**FINDINGS AND RECOMMENDATION
OFFICE OF PLANNING AND ZONING
ANNE ARUNDEL COUNTY, MARYLAND**

CASE NUMBER: 2024-0132-V

The applicant is requesting a variance to allow an accessory structure addition (second story) with less setbacks than required on property located at 8431 Bay Road in Pasadena.

PROPOSED SITE CONDITIONS
SCALE: 1"=30'

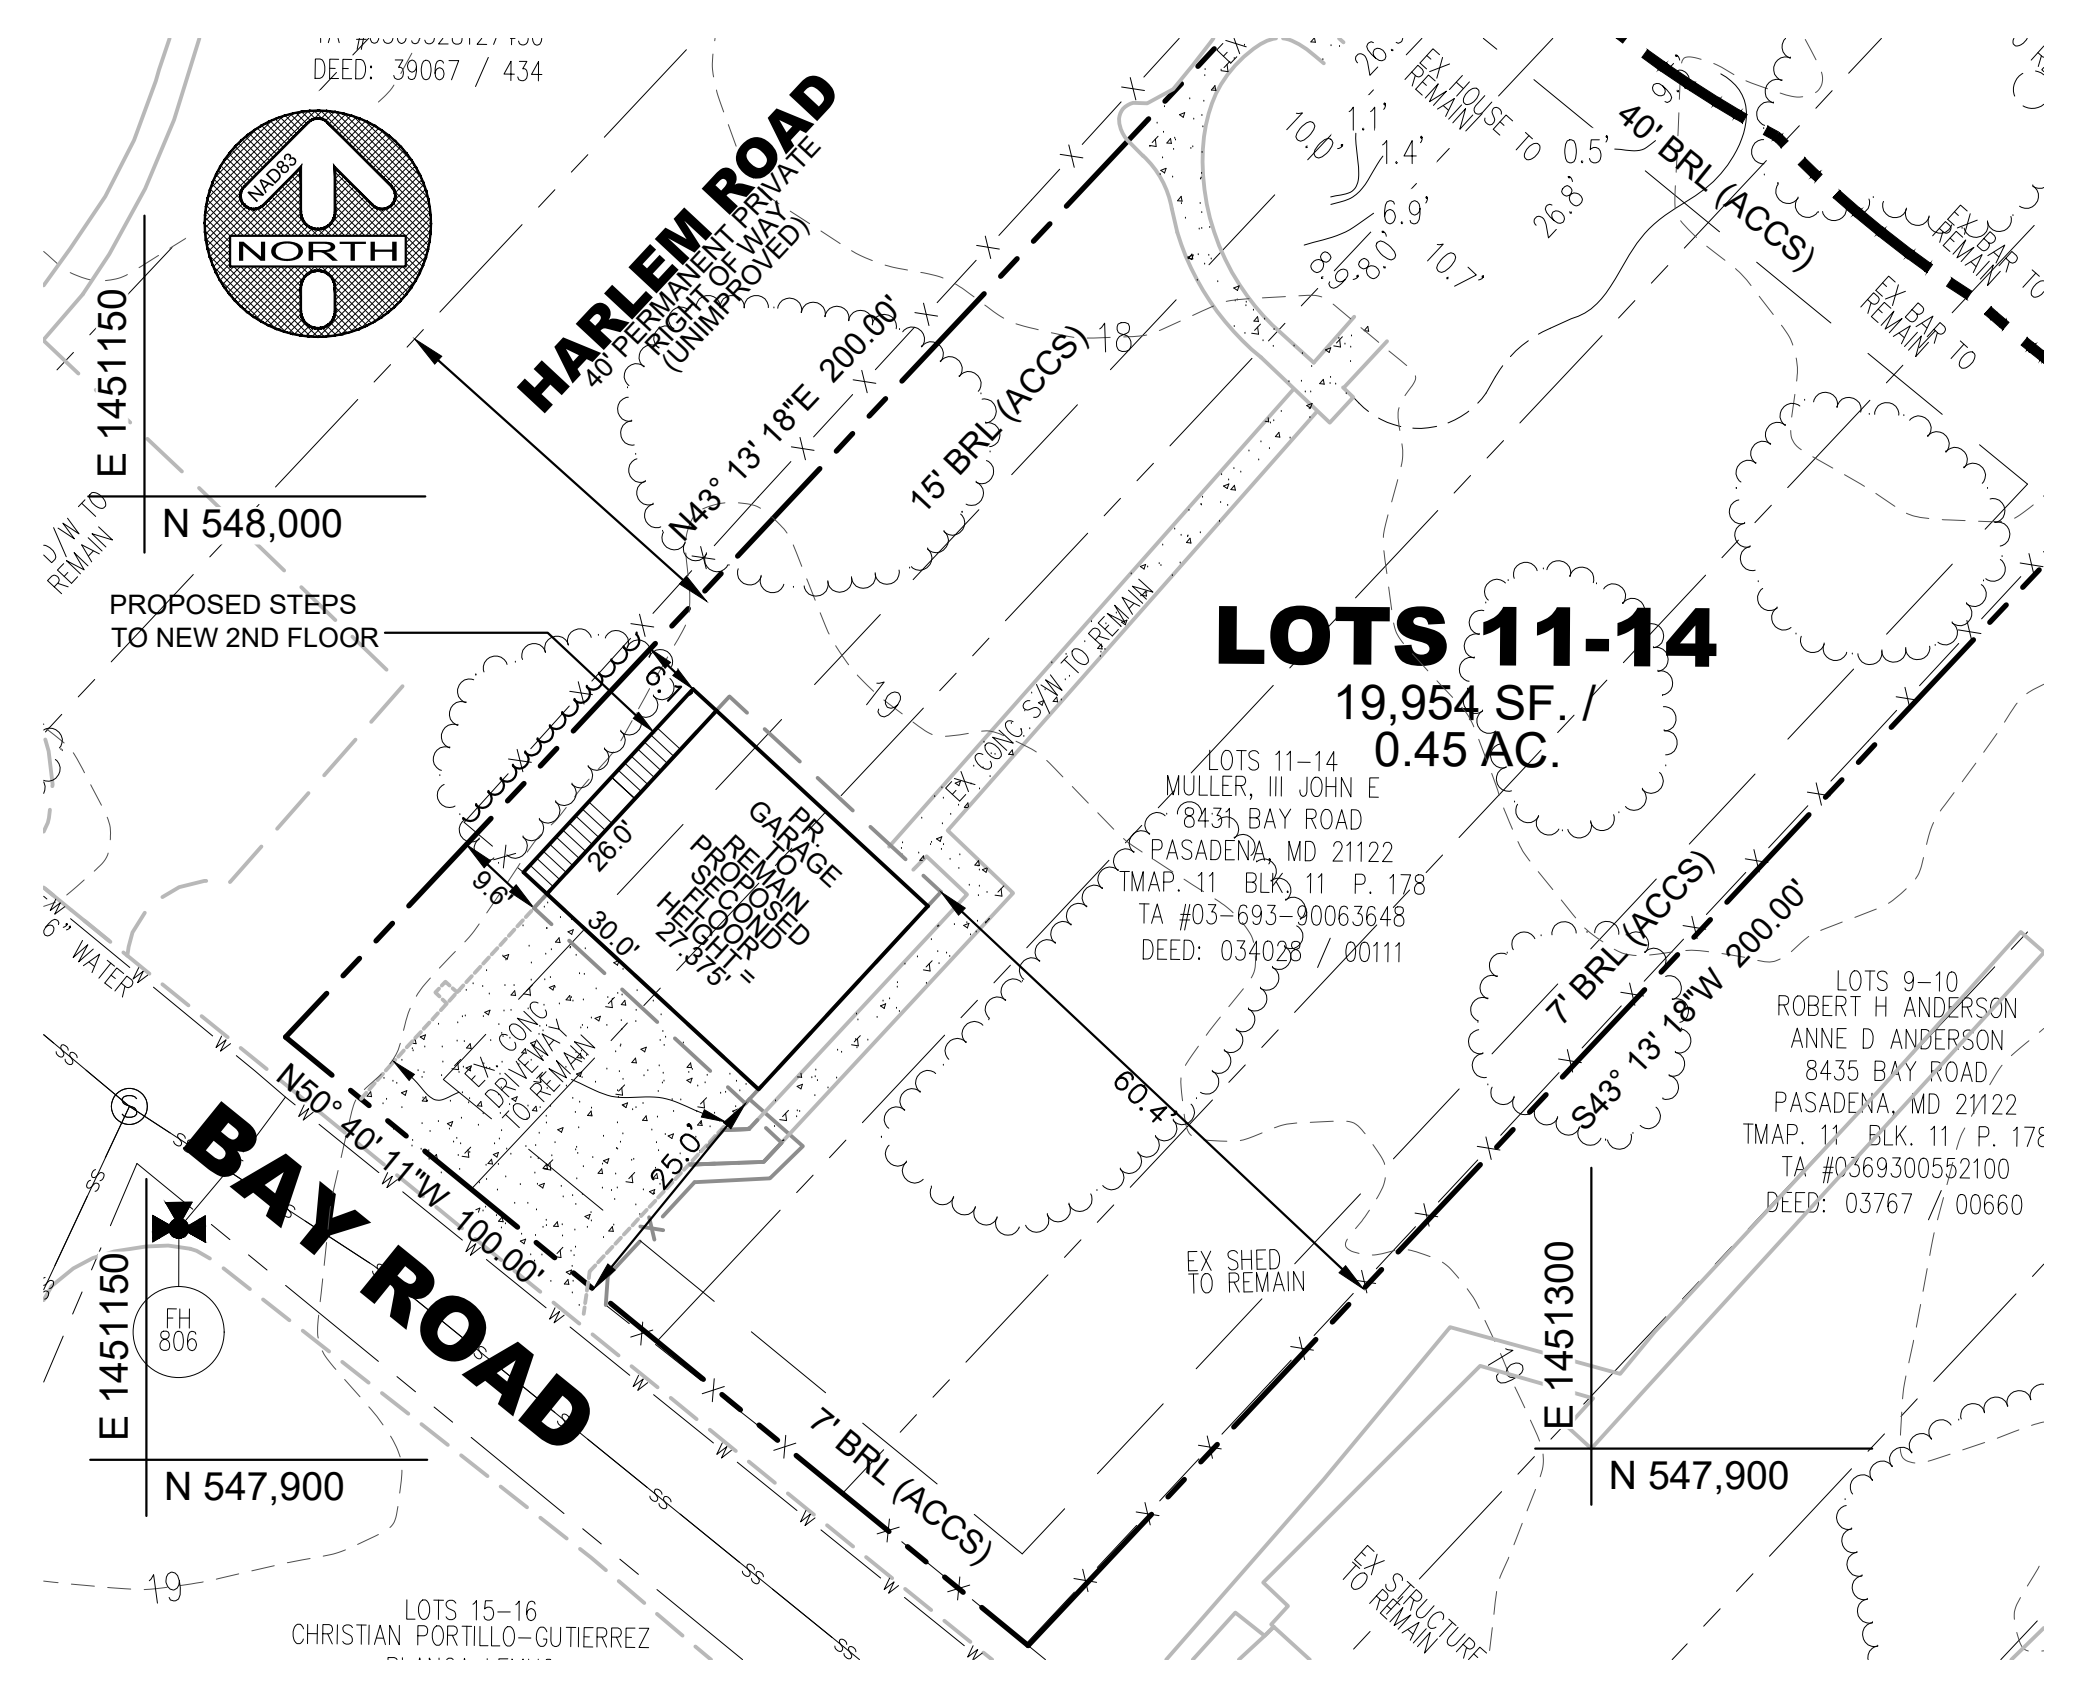
§ 18-4-701 of the Anne Arundel County Zoning Ordinance provides that an accessory structure in an R5 District shall be set back a minimum of 15 feet from the corner side lot line. The garage addition would be located as close as 9.6 feet from the corner side lot line, necessitating a variance of 6 feet.

§ 18-2-301(b) of the Code provides that steps required for access may extend no more than three feet into a required setback and be located no closer than five feet from any lot line. The proposed steps to grade will extend 8.9 feet into the corner side setback, necessitating a variance of 6 feet.

In this particular case, the applicant had been granted a variance to construct the detached garage in a location which does not comply with the current bulk regulations¹. As such, denying a variance to construct a second story on that structure due to its proximity to the corner side lot line would be an unnecessary hardship.

With regard to the variance for the exterior stairs, there is ample space on the opposite side, or rear, of the structure, which would eliminate the need for that variance. It appears that the

proposed floor plan of the ADU could be flipped, or redesigned, to accommodate exterior stairs while complying with the bulk regulations. Because justification was not provided and alternatives exist which would eliminate the need for relief, this variance cannot be considered the minimum necessary to afford relief.

Based upon the standards set forth in § 18-16-305 of the Code under which a variance may be granted, as proposed, this Office recommends ***approval*** of a zoning variance to § 18-4-701 to allow an accessory structure addition with less setbacks than required, and ***denial*** of a zoning variance to § 18-2-301(b) to allow steps required for access with more encroachment than allowed.
